Interactive comment on “Using paired catchments to quantify the human influence on hydrological droughts” by Sally Rangecroft et al.

J. Hannaford (Referee)

Interactive comment on Hydrol. Earth Syst. Sci. Discuss., <https://doi.org/10.5194/hess-2018-215>, 2018.

Fig. 1.

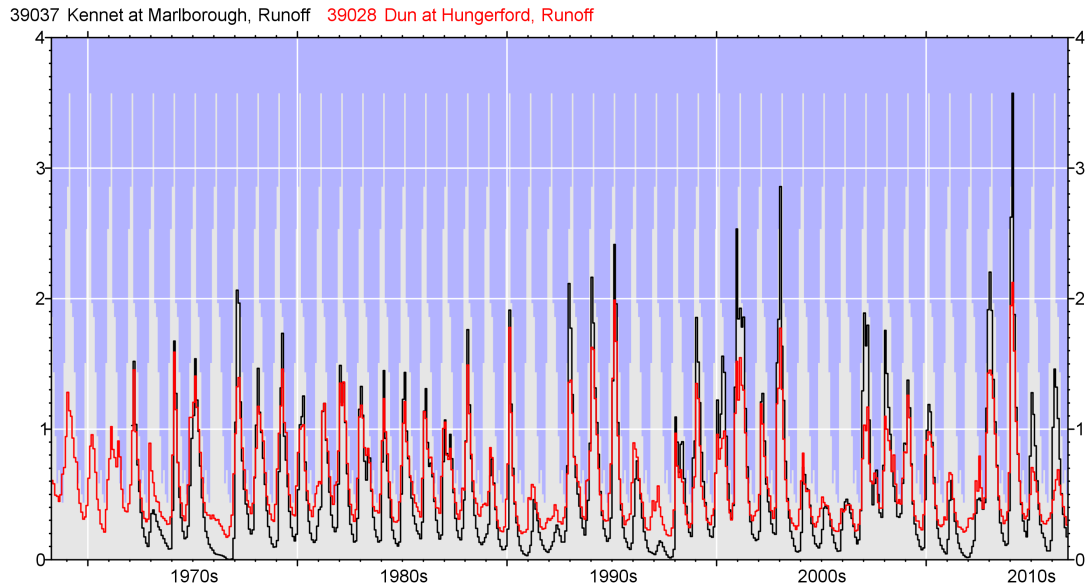
This becomes problematic when one looks in detail at a catchment pair. I have investigated this for the UK pair as I am more familiar with UK hydrology, and have not commented on the Australian example. The Dun and Kennet are very similar indeed in terms of rainfall and geology, and make a good starting choice of study catchments. However, we can still see that the flow regimes are quite different. See the attached graph showing the two series scaled as runoff in mm, to account for the different catchment areas, as in the paper. The Kennet has a greater range in flows, with higher high flows and lower low flows (notwithstanding the abstraction effect). The Dun is more muted. The catchments are different in terms of runoff response/catchment function, despite their similar rainfall.

I'm not entirely sure of why the two catchments differ in terms of response, but it is likely that hydrogeology is a major factor. As acknowledged by the authors, in such chalk dominated catchments, the size/nature of the contributing catchment can be very different to the topographic catchment. Moreover, the geology of the chalk is heterogeneous and very complex.

The different regimes will have a significant bearing on the derived Q80. The net result

is (likely) that the natural Q80 transferred from the Dun is a biased estimator of the 'theoretical natural' flow of the Kennett. Given the more limited range of the Dun flows, my guess is the Q80 of the Dun will be somewhat higher, leading to inflated values for the deviations that are used to infer aggravated drought due to human effects.
